RE: Stormwater Management Report – Response Letter  
South Hadley High School – Athletic Campus Improvements  
Gale JN 717000

Gale Associates, Inc. (Gale), on behalf of its client, Town of South Hadley (Town), hereby submits this letter response to the peer review comments by Fuss & O'Neill (F&O) to the Stormwater Management Report, dated February 26, 2016, regarding the athletic campus improvements project proposed at the South Hadley High School.

### Pond 1P: Base Stone (Turf Field)

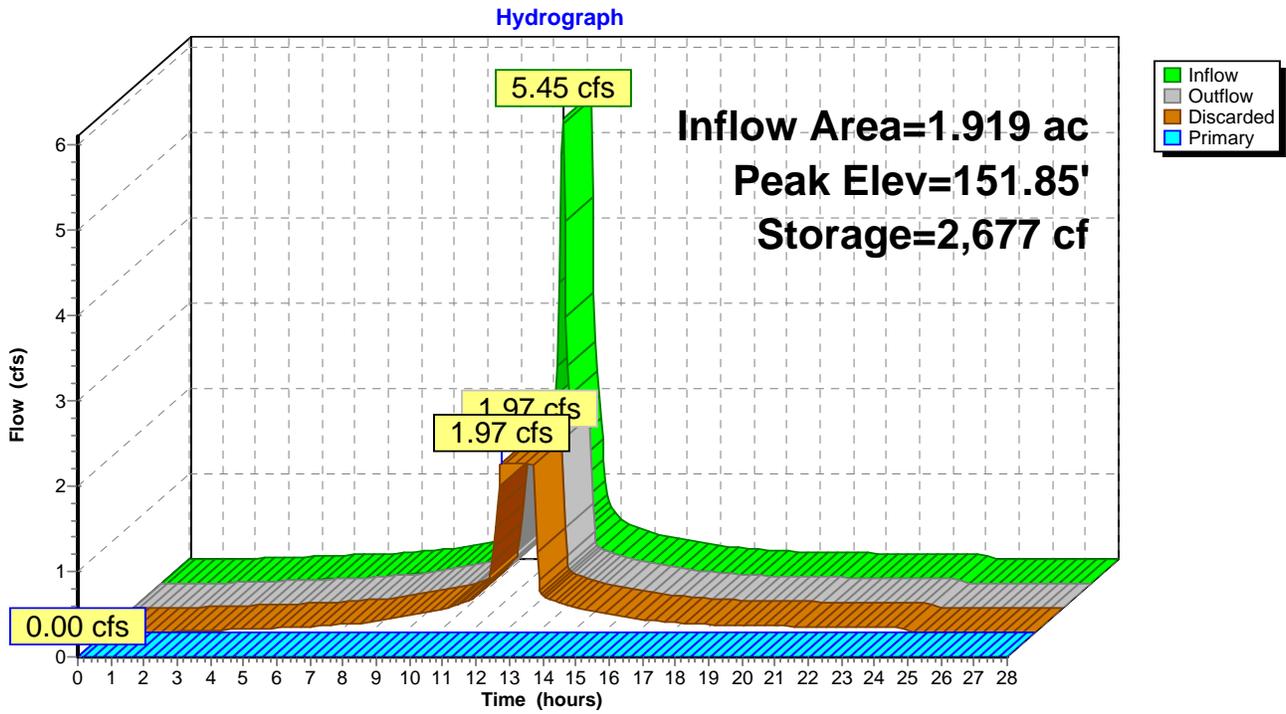
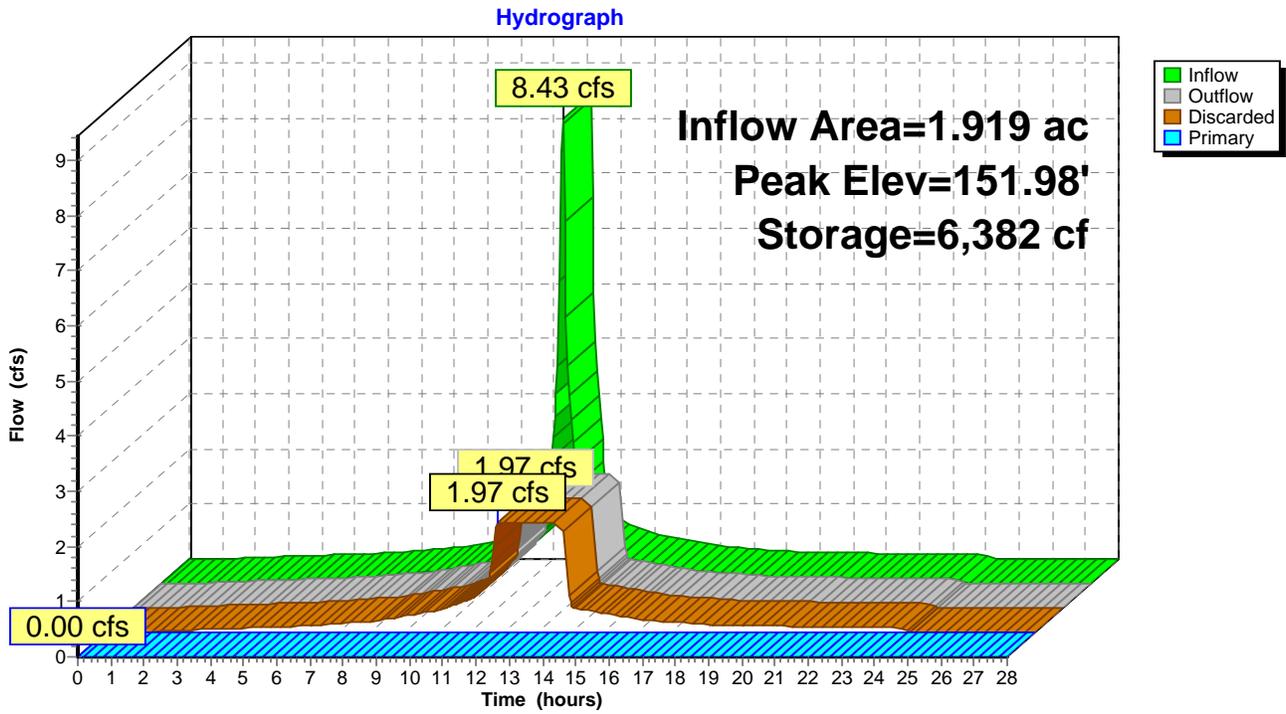
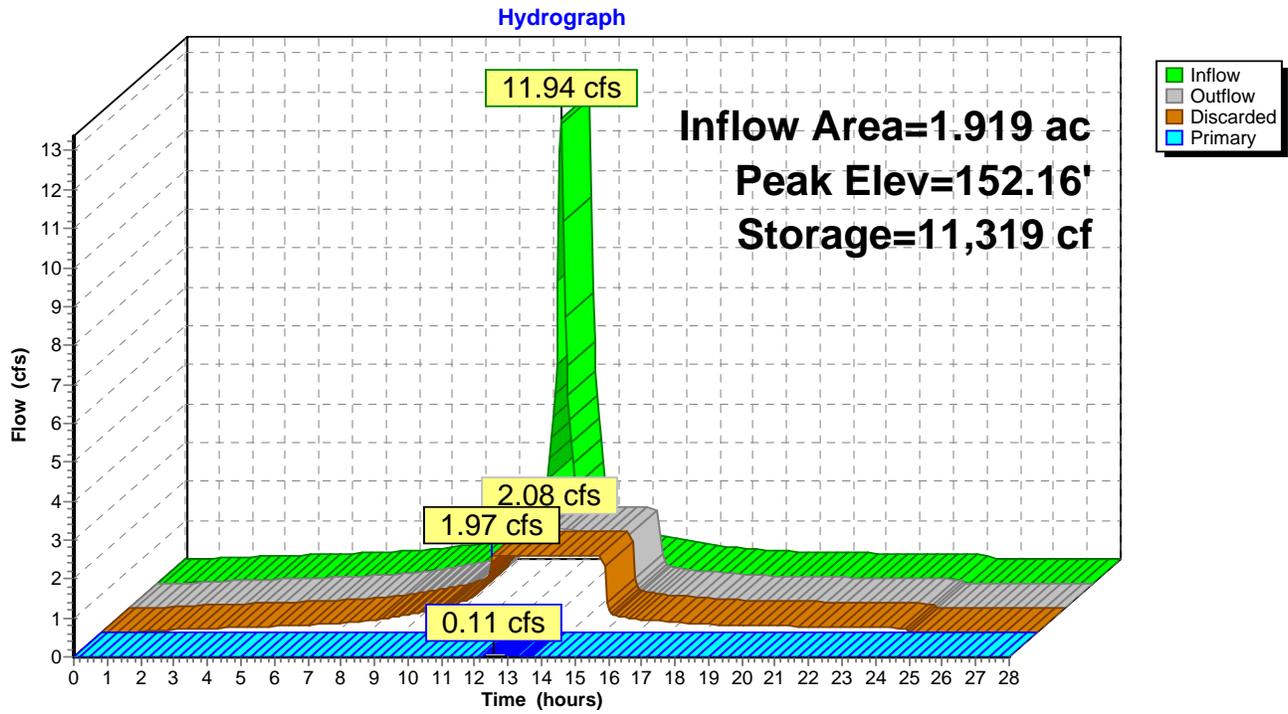
1. There appears to be a discrepancy between the proposed HydroCAD model of the outlet devices for Pond 1P: Base Stone (Turf Field) and what is depicted on the plans. Please clarify.

**The proposed outlet in the model was changed from 10" to 12" in order the represent what is depicted on the plans. The post-development peak runoff flows remain the same and are below the pre-development flows. Please see attached revised stormwater model.**

DRAWING NO.	C101
PROJECT NO.	717000

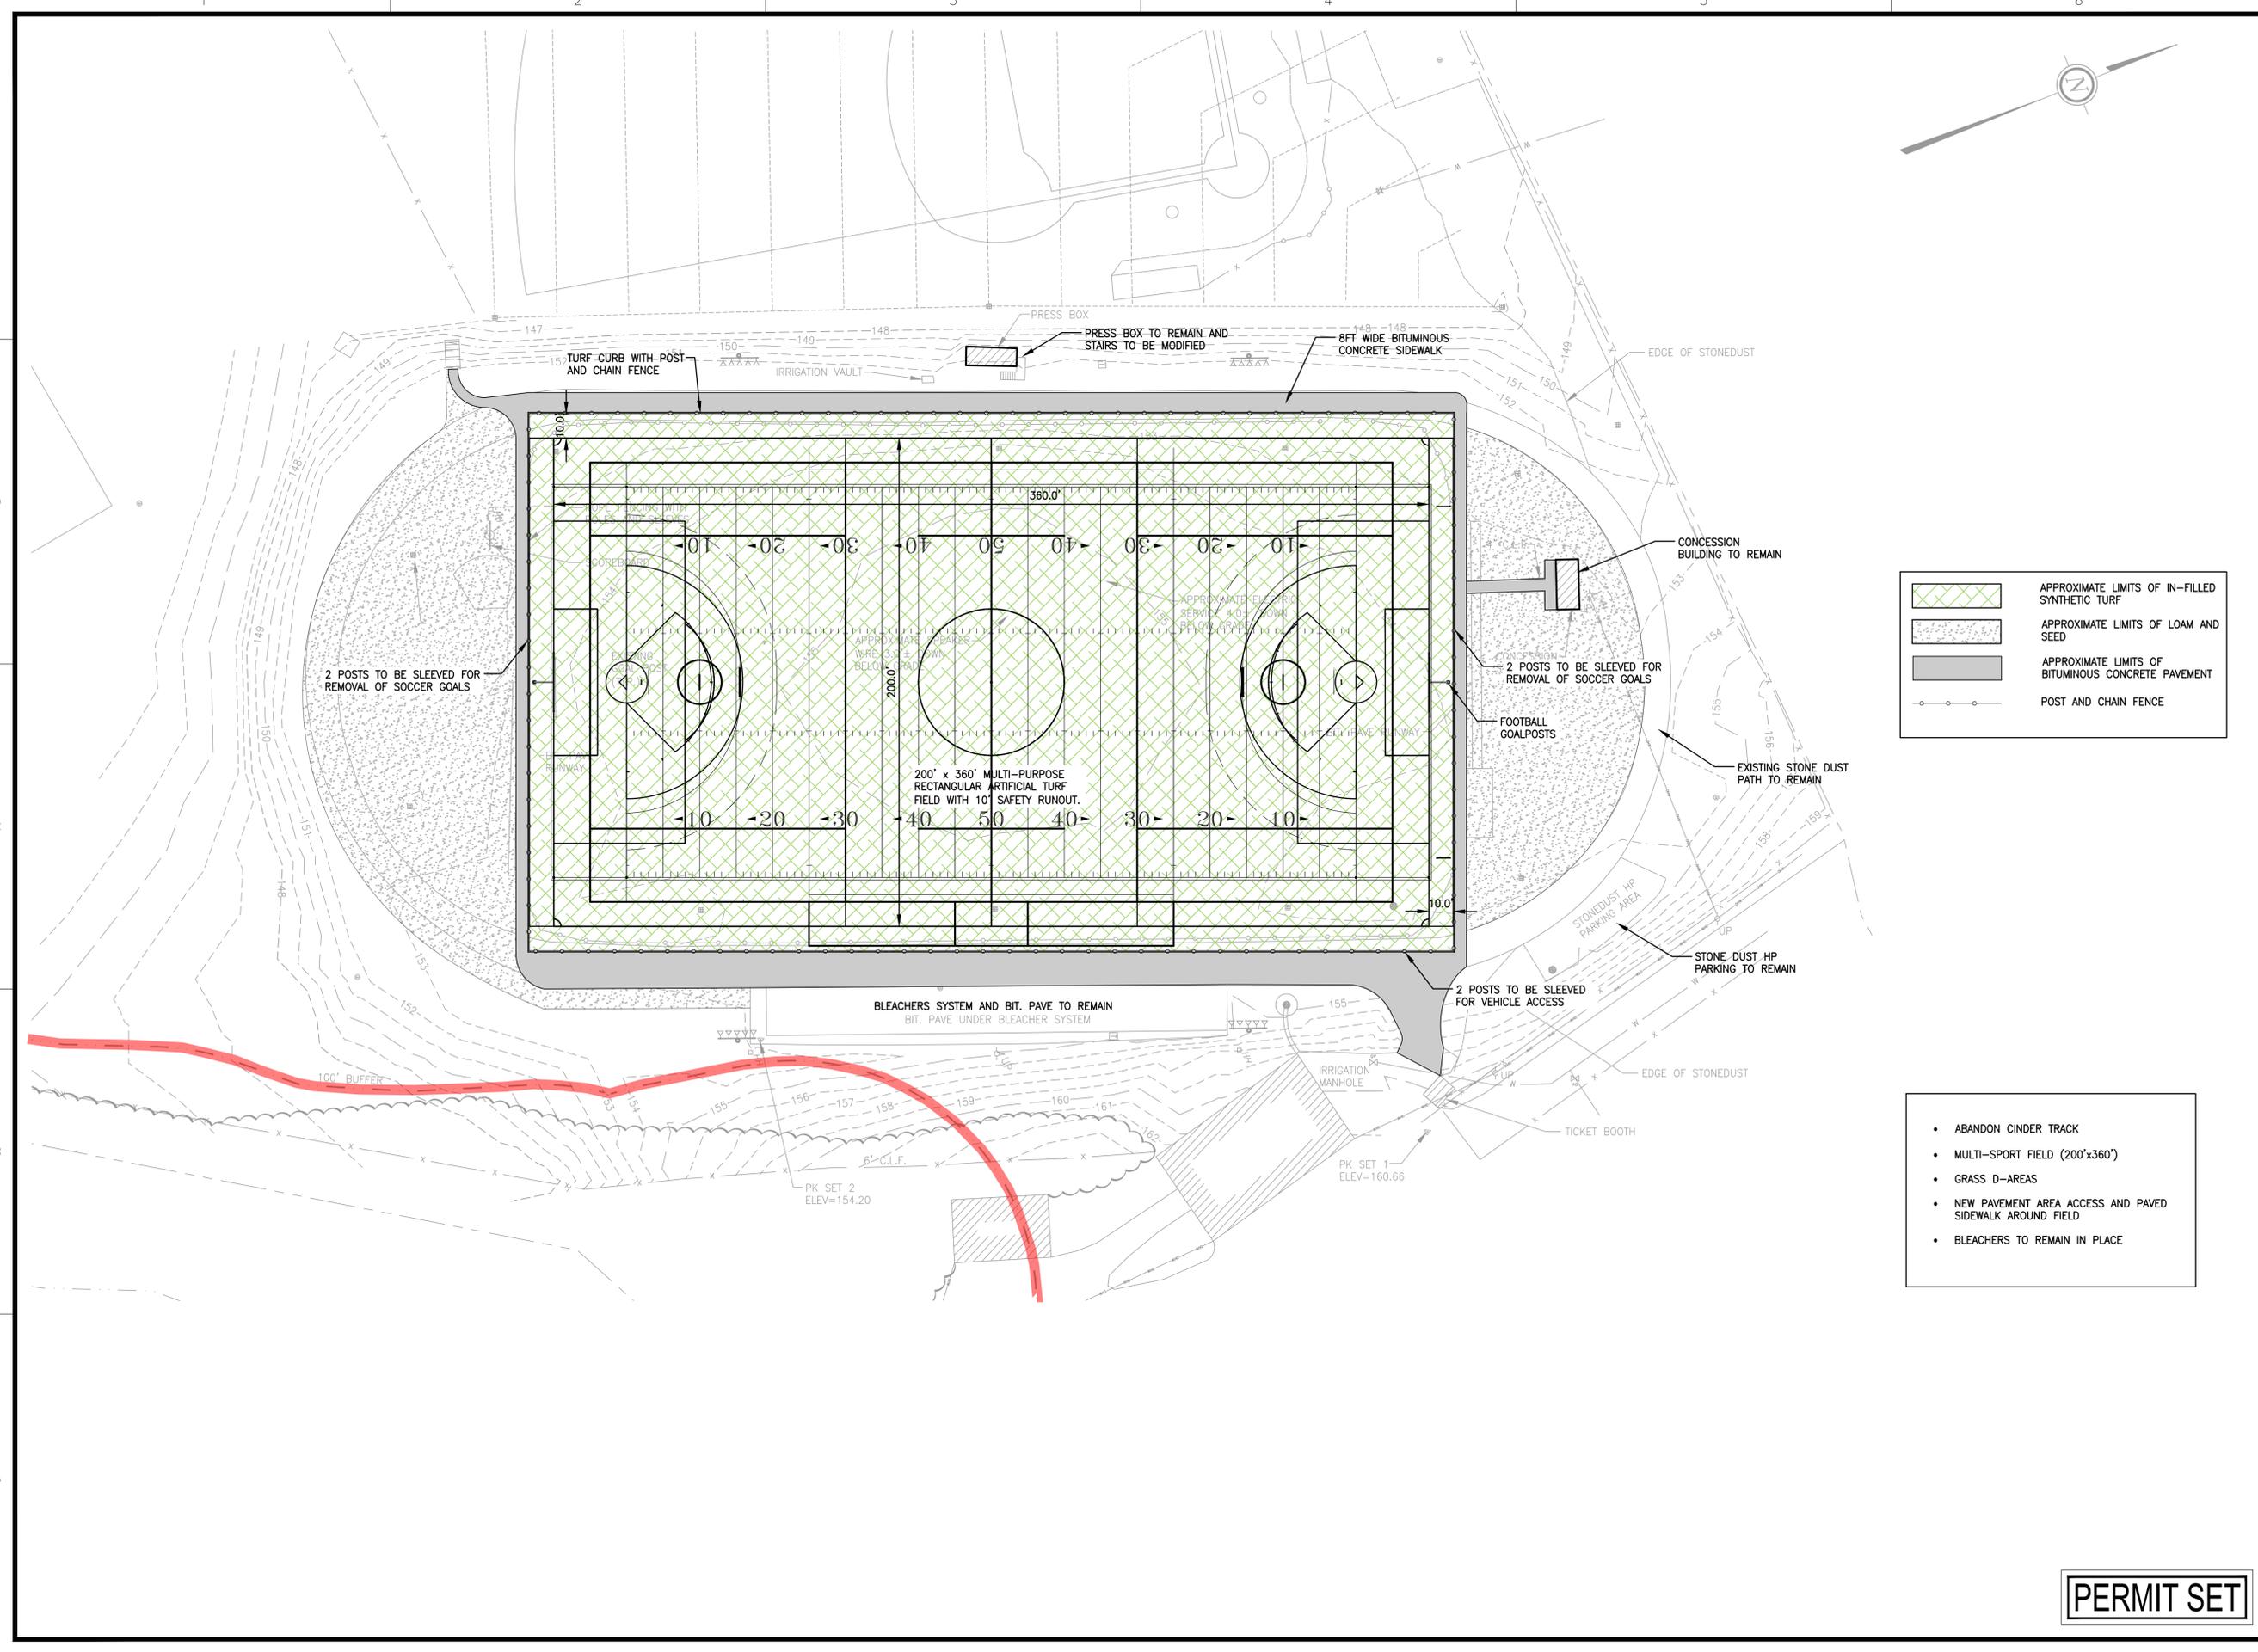
2. It is difficult to determine where the wetland buffer lies, please identify the wetlands buffer on plans.

**Please see attached PDF of the plan with the wetland buffer highlighted. Gale met with Ms. Janice Stone, the Town's Conservation Administrator prior to the Planning Board meeting on February 29, 2016 to review the wetland buffer lines and potential impacts. Ms. Stone was in agreement that the proposed project work is outside the wetland buffer and should not have off-site impacts.**
